U.S. NUCLEAR WASTE TECHNICAL
REVIEW BOARD

Report to
The U.S. Congress
And
The U.S. Secretary of Energy

November 1998

Figure 1-3. Estimated Sensitivity of Dose Rate to Unsaturated Zone Seepage (Andrews 1998b)

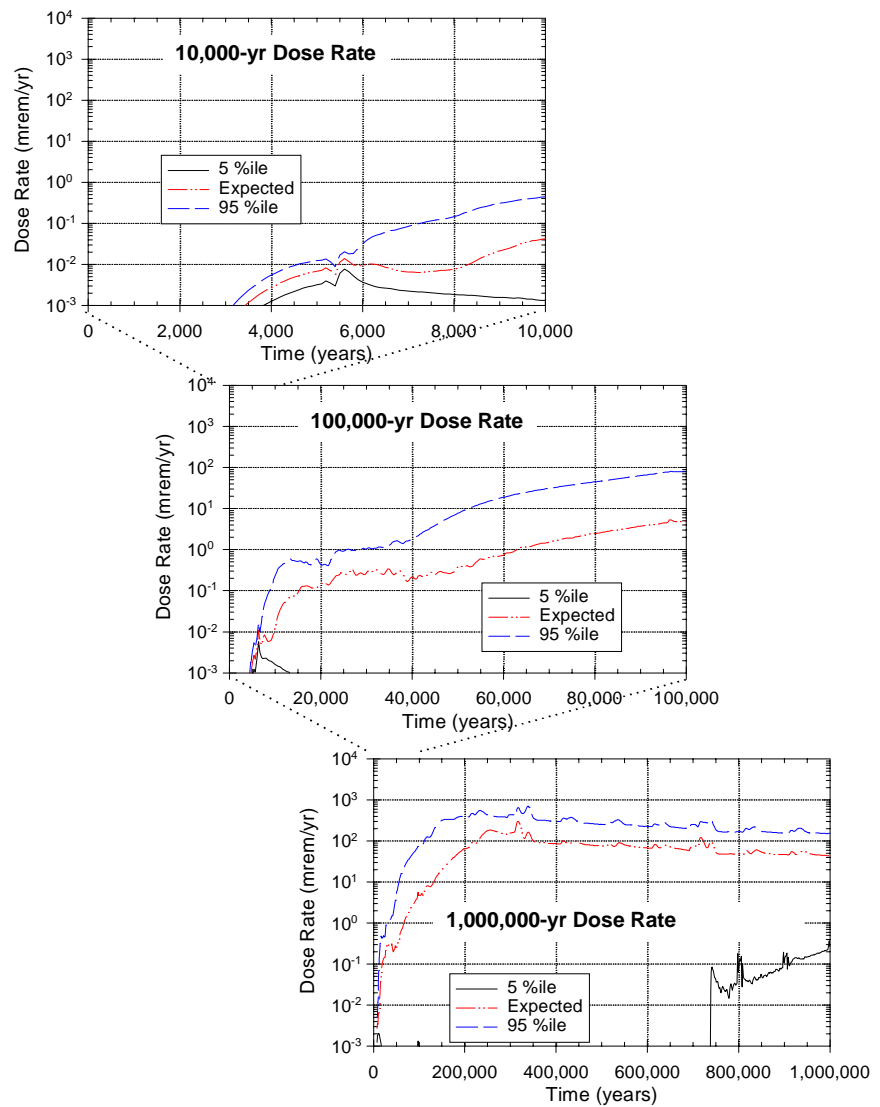
percentiles. The 5th percentile represents parameter values that result in low seepage, and therefore low dose rates; the 95th percentile shows how parameter values that cause higher seepage also cause higher doses. Dose rates over time for the 5th, 50th, and 95th percentiles of the seepage flux are illustrated in Figure 1-3.

Figure 2-2. Breakthrough Curves for Superpluvial (SP), Long-Term Average (LTA), and Present Climates (Andrews 1998b).

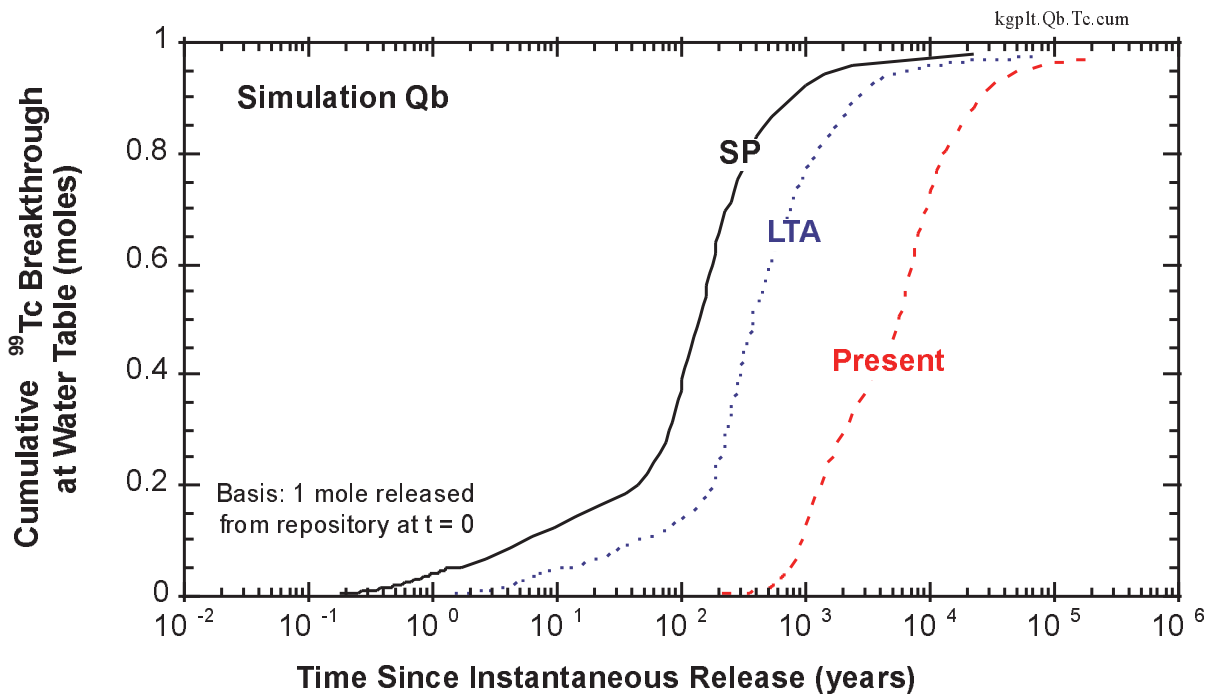
In Figure 2-2, the distributions of travel times from the repository to the assumed level of the water table can include some very rapid values. For example, 50 percent of radionuclide travel times are predicted to be several hundred years or shorter during superpluvial conditions. The travel-time distribution through the UZ has not been quantified through direct measurements. It is highly model-dependent and yet is significant for performance. Although very fast travel times through the UZ exist (e.g., bomb-pulse ^{36}Cl discovery in the ESF), these times might represent only a very small fraction of flow. The uncertainties remain large, and the significance of the UZ as a barrier is uncertain.

It is important to determine the extent to which the breakthrough curve of Figure 2-2 may be an artifact of the way transport through the UZ is modeled. Travel times through the natural barriers represent an important component of a defense-in-depth repository design, especially in case of premature canister failure. Current TSPA models (e.g., base case for VA) assume that a fraction of the flow takes place through fractures and that this component of flow leads to fast travel times through the UZ. These models may not adequately represent the physics of flow within the fractured rocks of the UZ at Yucca Mountain. More data and better models are needed to demonstrate whether radionuclide travel times through the UZ could be significant (thousands of years), allowing the UZ to serve as a substantive natural component of a multiple-barrier repository design.
